County of Harnett  
Building Inspections Department  
Planning Services

**Certificate of Compliance: \_\_\_\_\_ Occupancy:**

Address: 386 Carolina Oaks Cir

(REPAIR / 29111 - FT13)

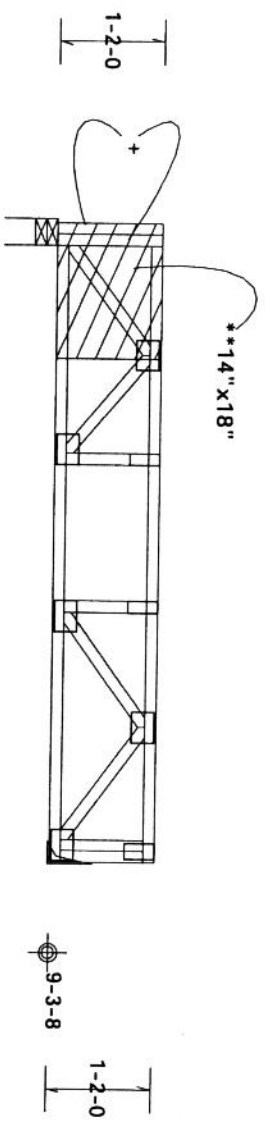
This truss is repaired to remove 3.5" from the left end and then add 3" back to the left end as shown. Refer to drawing R8976 11202026 for plates and other data not given here.

++ CAREFULLY REMOVE UNWANTED PORTION OF TRUSS SHOWN. REMAINING PORTIONS OF TRUSS AND ALPINE PLATES MUST REMAIN FULLY EMBEDDED & FREE FROM DAMAGE.

+ FIELD APPLIED 4X2 SP #2 (OR BETTER) MEMBERS, CUT TO FIT TIGHT IN PLANE OF THE TRUSS. NOTE 2 NEW MEMBERS ADDED.  
 \*\* (2) NEW 1/2"X(SIZE SHOWN) TRIMMED TO FIT APA RATED 32/16 SHEATHING (PLYWOOD OR OSB) ATTACH ONE GUSSET TO EACH FACE OF THE TRUSS WITH 1 ROWS OF 0.128"X3.0" NAILS SPACED 3" OC., THROUGHOUT ALL MEMBERS WITHOUT SPLITTING THE LUMBER.
